SEWAGE DISPOSAL SYSTEM

MARYLAND STATE DEPARTMENT OF HEALTH

SUBDIVISION _____ ROAD 11160 Douglas Road LOT _____

PROPERTY OWNER T. M. Franklin

P 35250

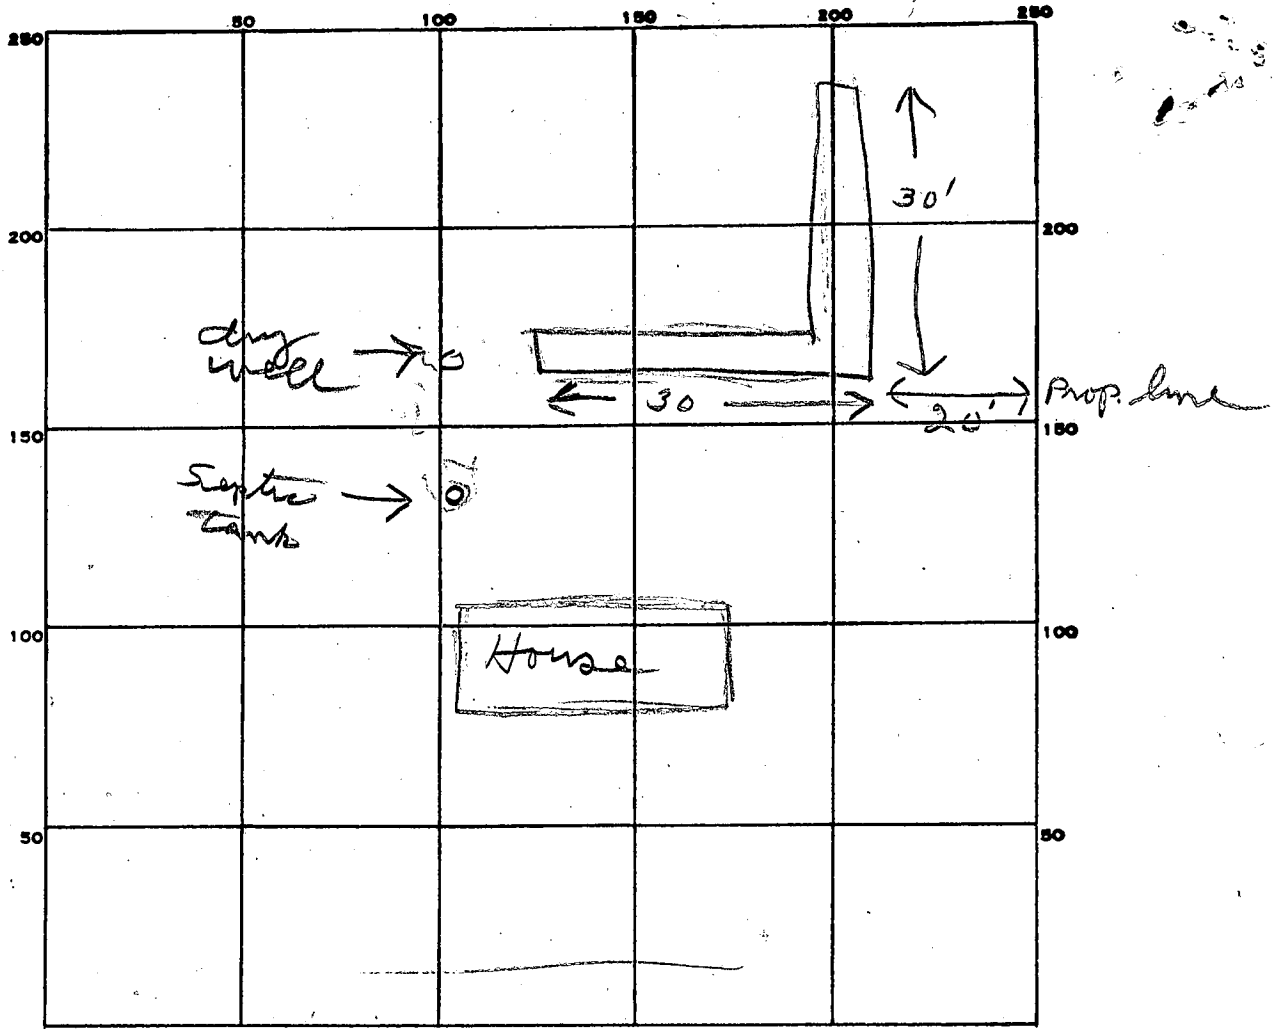
REMARKS EXISTING DAYWELL WITH VERY SHALLOW TRENCH RUNNING DOWN HILL.

SHALLOW TRENCH TO BE DISCONNECTED AND 60' TRENCH 9 FT DEEP W/TH 6 FT STONE TO BE ADDED. CW

4-10-85 TRENCH OK TO ADD STONE. CW

4-10-85 OK TO COVER ALL WORK. JS
